Contract Documents

Contract Number: 201846567

River North Park

SHEET NUMBER: DM1.2

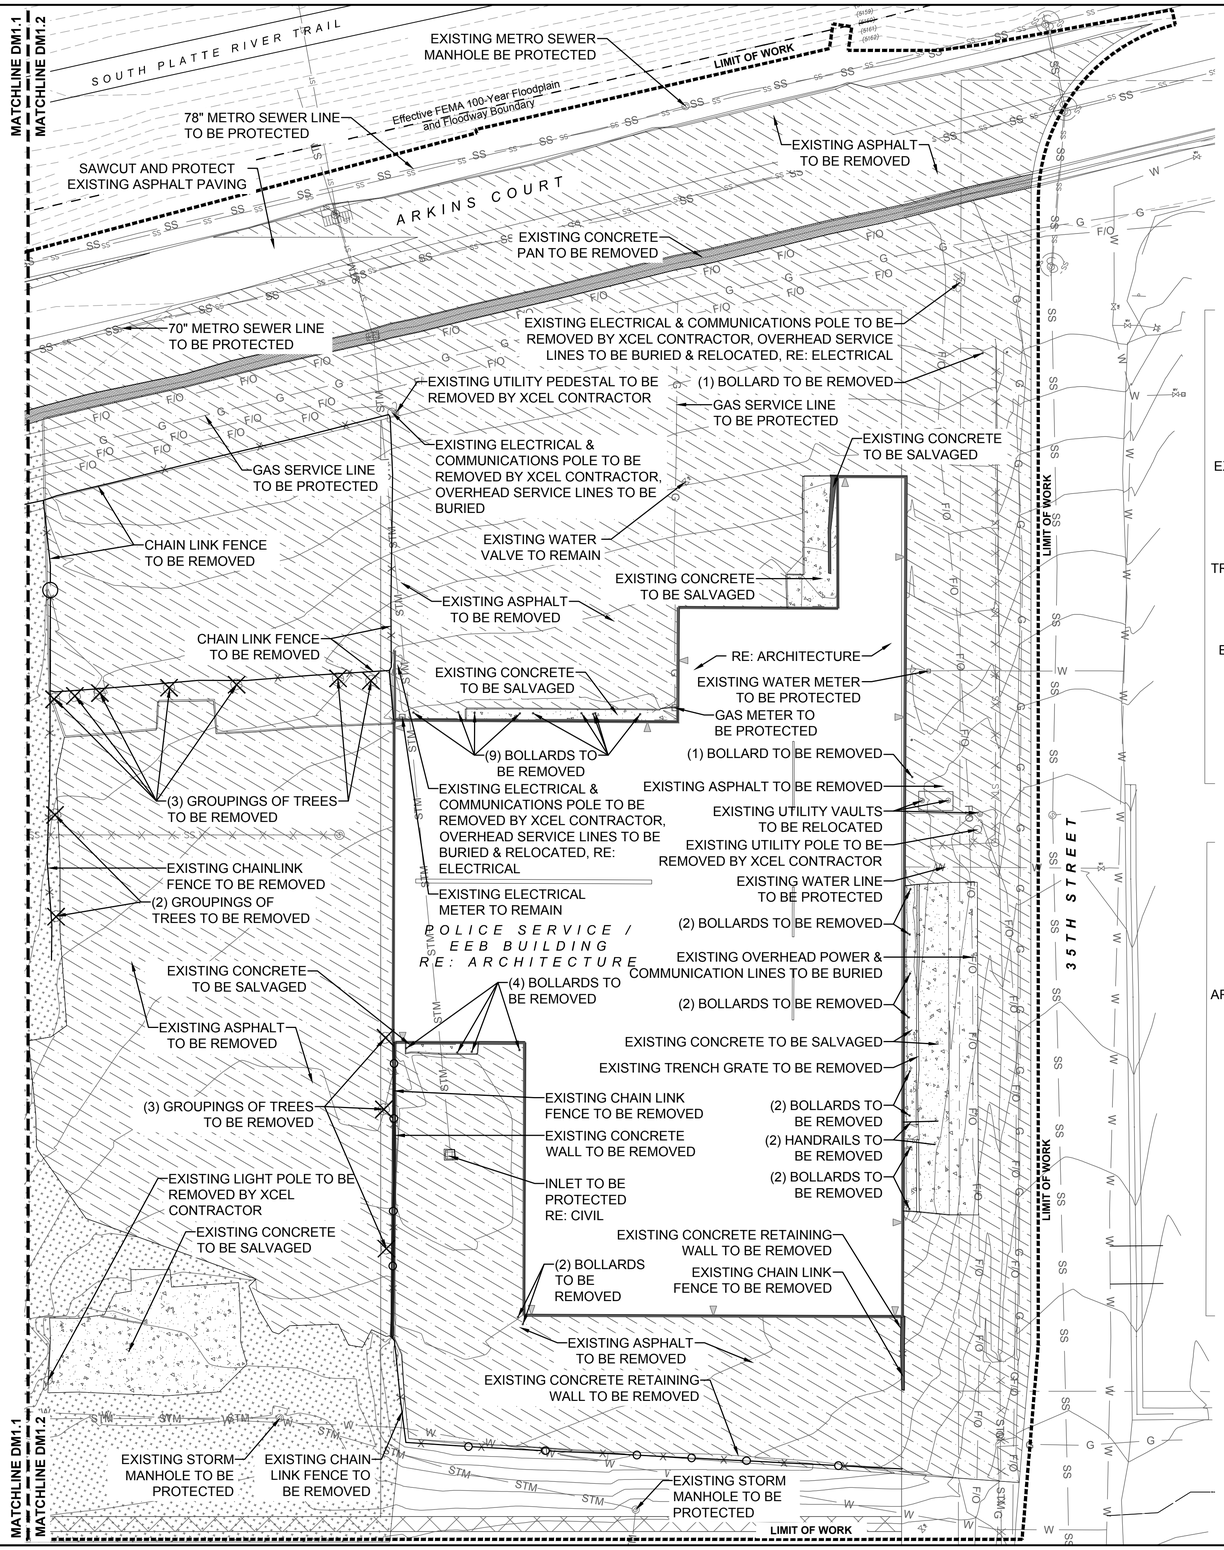
Q11: In reference to Plan Sheet DM 1.2 and Maker's Plaza-EEB Floor Enlargement. Plans indicate that the central portion of the Police Service/EEB Building is to be demolished and the west and east portions are to remain. Notes on the plan call out to *"RE: Arch for Roof, Wall & Interior Demolition plans, TYP"*. *"Preserve Walls & Columns, TYP. Unless otherwise noted in architecture sheets"*. There are no Architectural Drawings, Technical Specifications or Bid Items for this scope of work. Please clarify with additional information.
A11: See updated DM 1.2 sheet for extent of demo in Schedule B for Maker's Plaza. The construction of Maker's Plaza will include a building demo and construction scope of work that is not included in this contract. The building work will commence in a similar timing as this Park contract and the Park general contractor is expected to coordinate with the building contractor on the sequencing and scheduling for Maker's Plaza demo in Schedule B.

SHEET NUMBER: C2.1

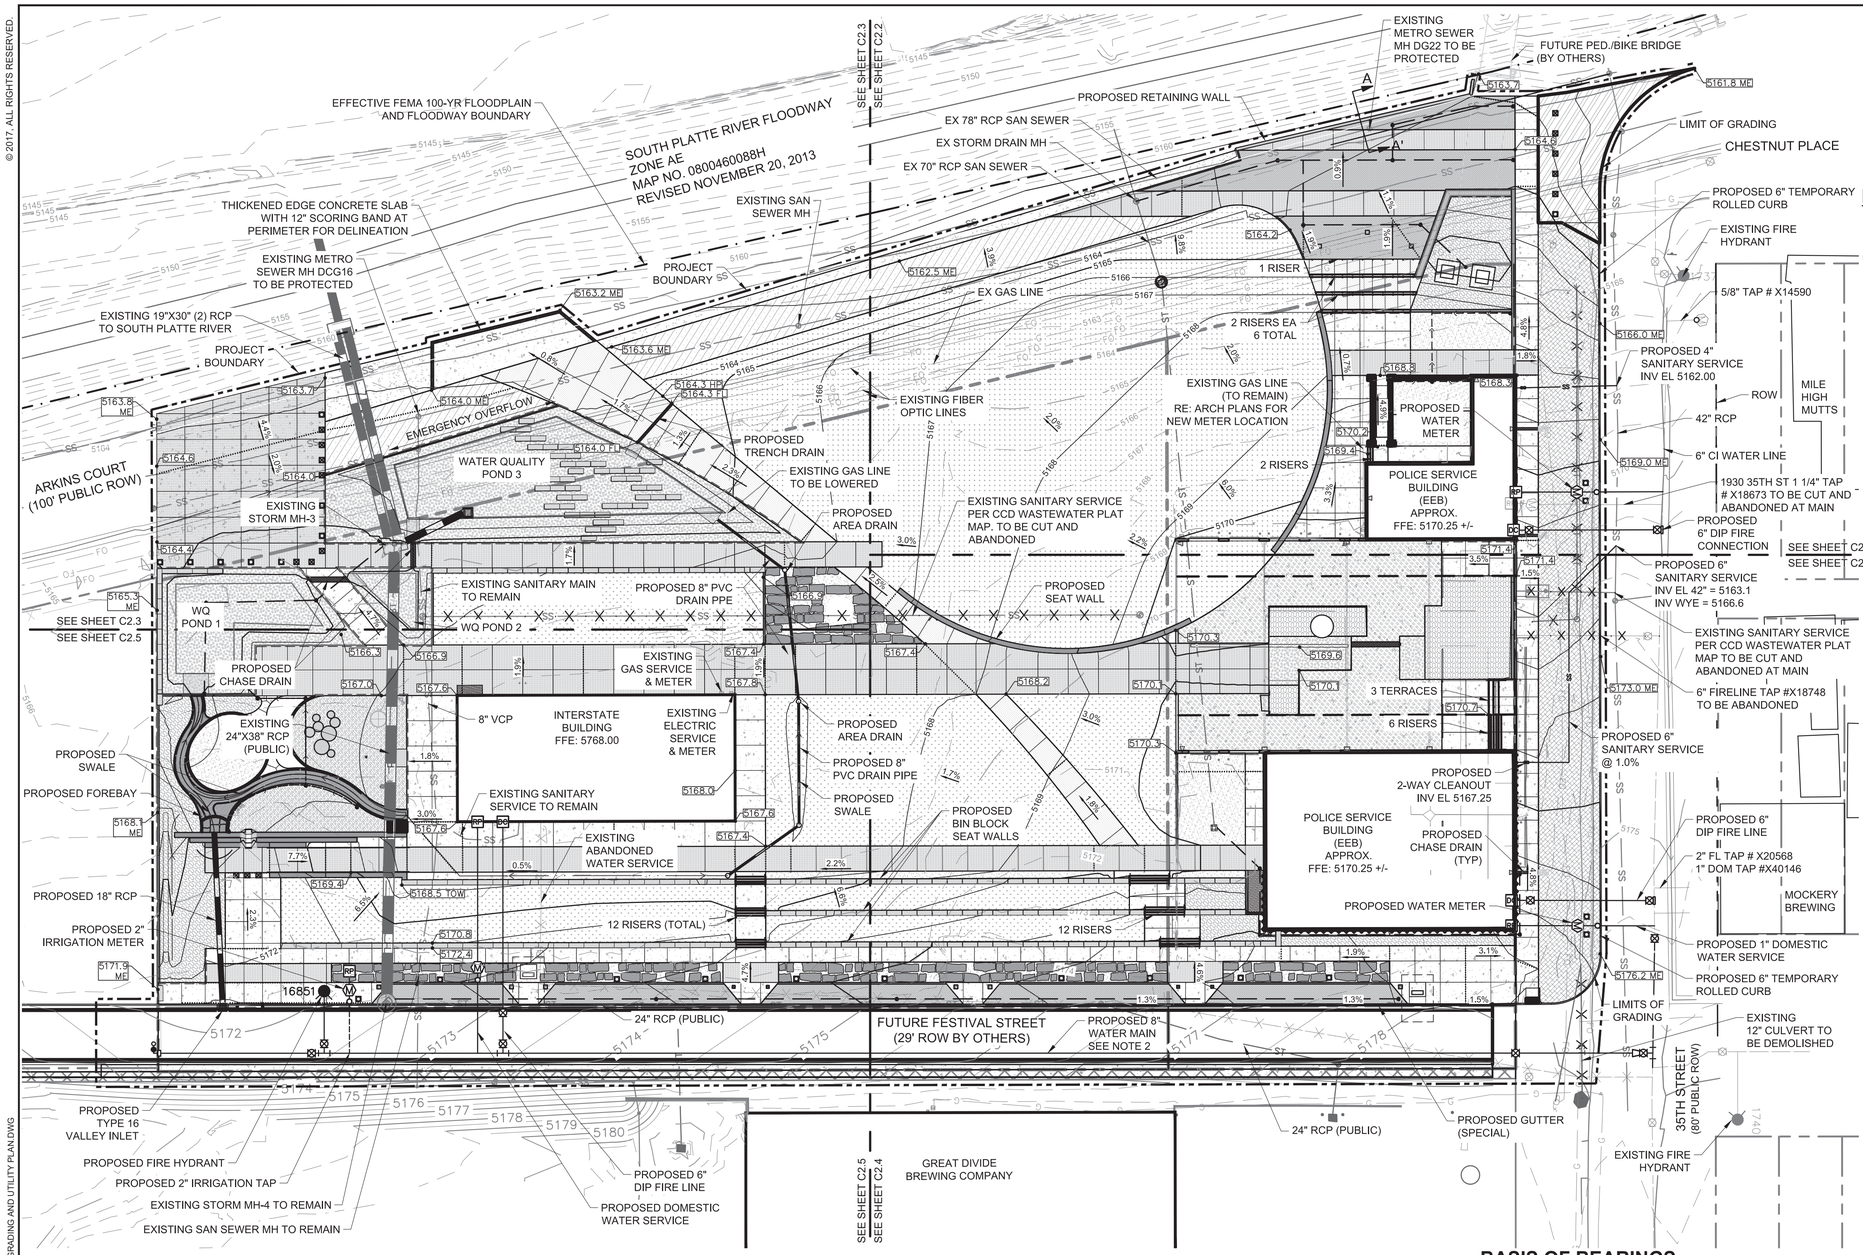
Q6: Sheet C2.1 & C6.2 show a Water service line; Sheet C2.1 Call out a 1" line and on sheet C6.2 calls out a 1.5" line. Please advise which size of line is required.
A6: Refer to C6.2, the 1.5" line is required.

Q8: Sewer services on sheet C2.1 shows and 4" & 6" line while C6.3 shows these lines to be 4". Bid docs do not call out size of line; please advise what size of line is required for the sewer service line.
A8: C2.1 is correct, demonstrating both a 4" and a 6" line.

DRAWN BY: JLH
REVIEWED BY: JSP
PROJECT NUMBER: 15014
DATE: **OCTOBER, 2018**
ISSUE: BID SET
SHEET TITLE: STORM SEWER PLAN & PROFILE
SHEET NUMBER: C5.3

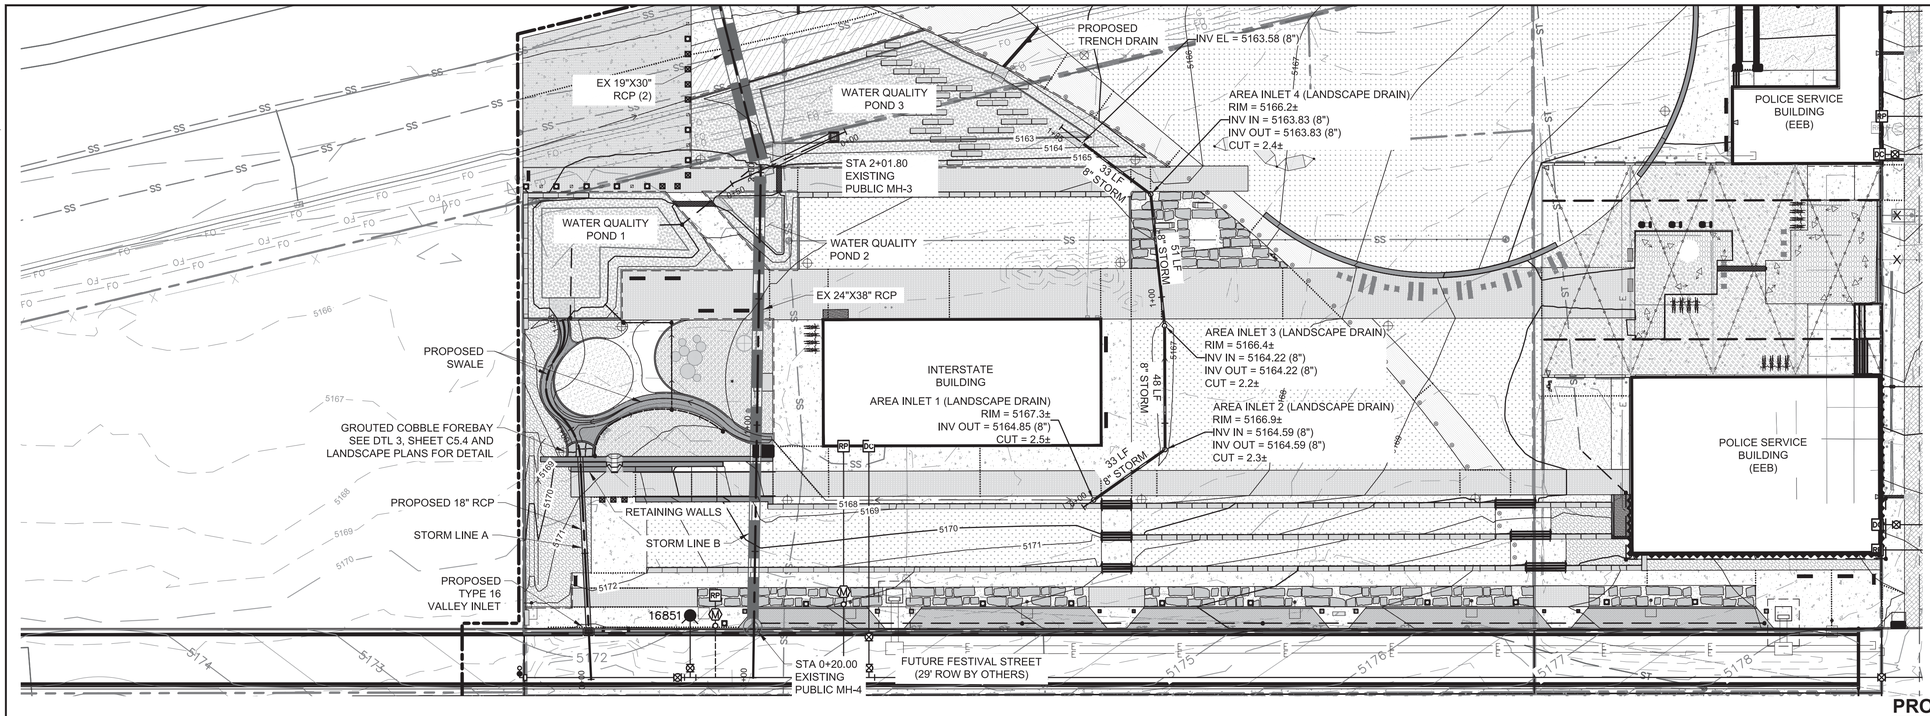
Q3: Sheet C5.3; can you please clarify if the 8" Storm Pipe is considered underdrain? The bid form does not show 8" storm. Please advise.
A3: 8" storm pipe is considered underdrain. The bid quantity should 165' not 155'. (See revised bid form number 334400-3).

SHEET NUMBER:
C6.2

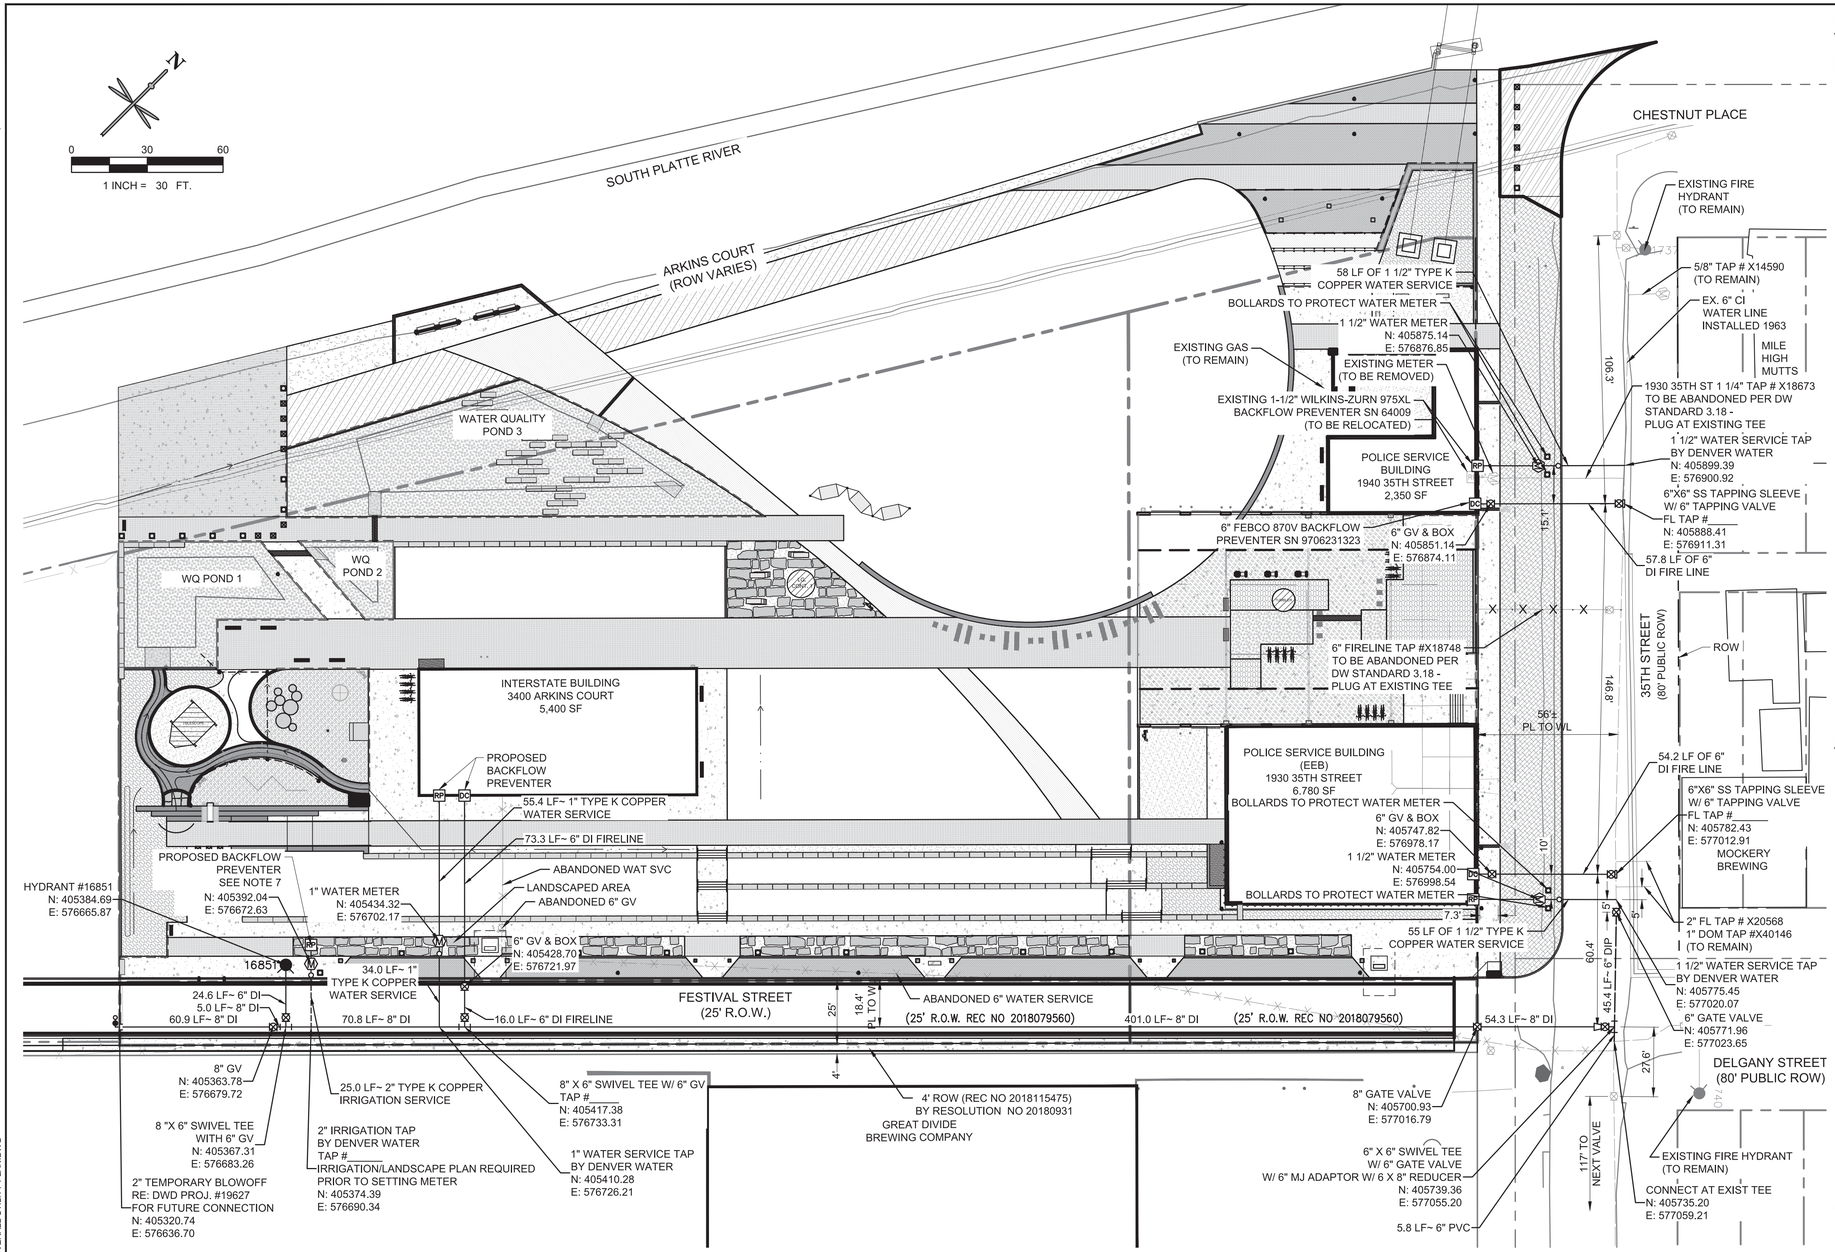
Q1: Sheet C6.2; shows 5.8 LF of 6" PVC; there is no 6" PVC on the bid docs. Can you please advise where 6" PVC be accounted for in the bid docs.
A1: A new bid line will be added to the bid form for 5.8 LF of 6" PVC. (See new bid form number 331416-12 on page 6.19).

Q2: Sheet C6.2; the plans call out 8" DIP, the bid docs show 8" PVC. Which material is required for the 8" line shown on sheet C6.2 PVC or DIP? Please advise.
A2: The 8" line is DIP; and quantity should be 587 LF not 531 LF. (See revised bid form number 331416-3 on page 6.18).

SHEET NUMBER: L1.1

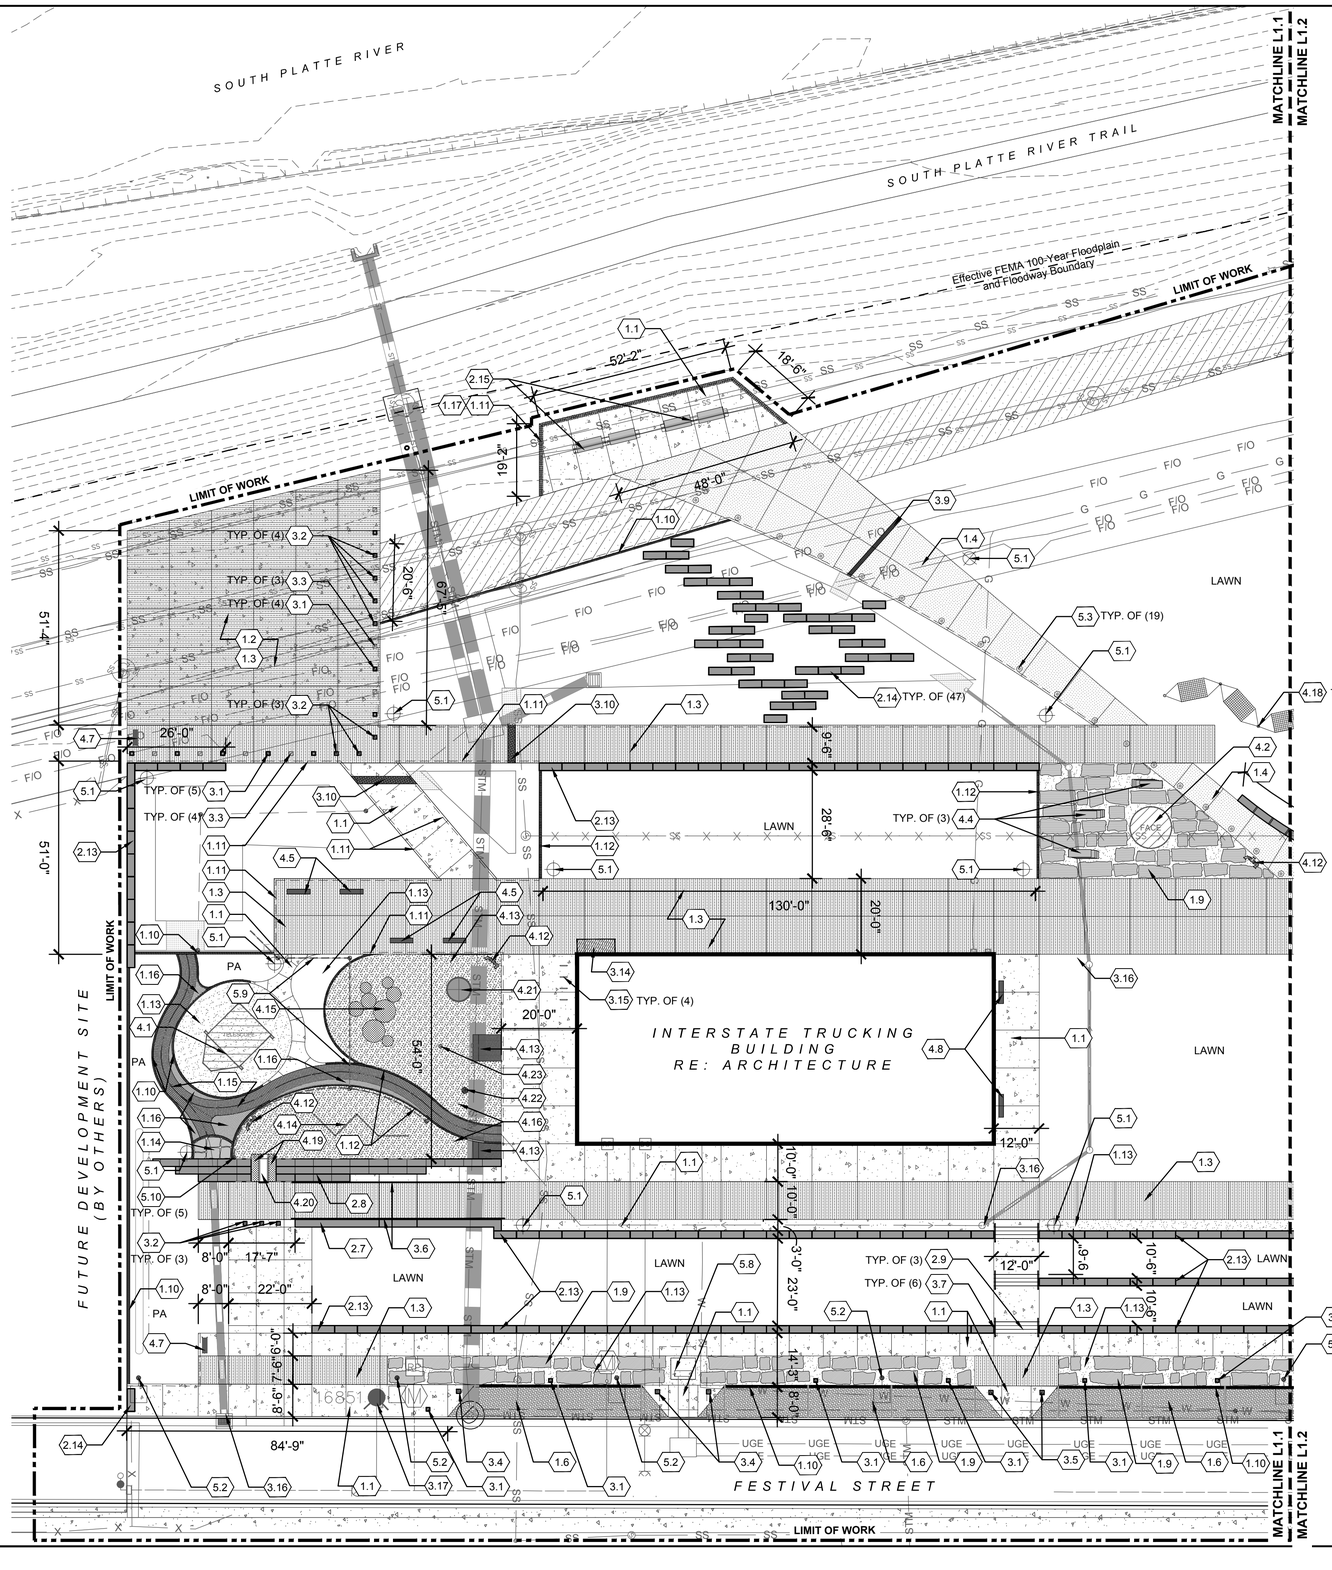
Q4: For the landscape perforated and solid underdrain; this material is not shown clearly on the plans; please advise where the landscape underdrain is located.
A4: Reference Sheet L1.1, detail callout 5.9, in the play area south of the Interstate Building, visible between the cleanouts (detail callout 5.10). Reference Sheet L1.2, detail callout 5.9, in the crusher fines areas west of the EEB Building 2.
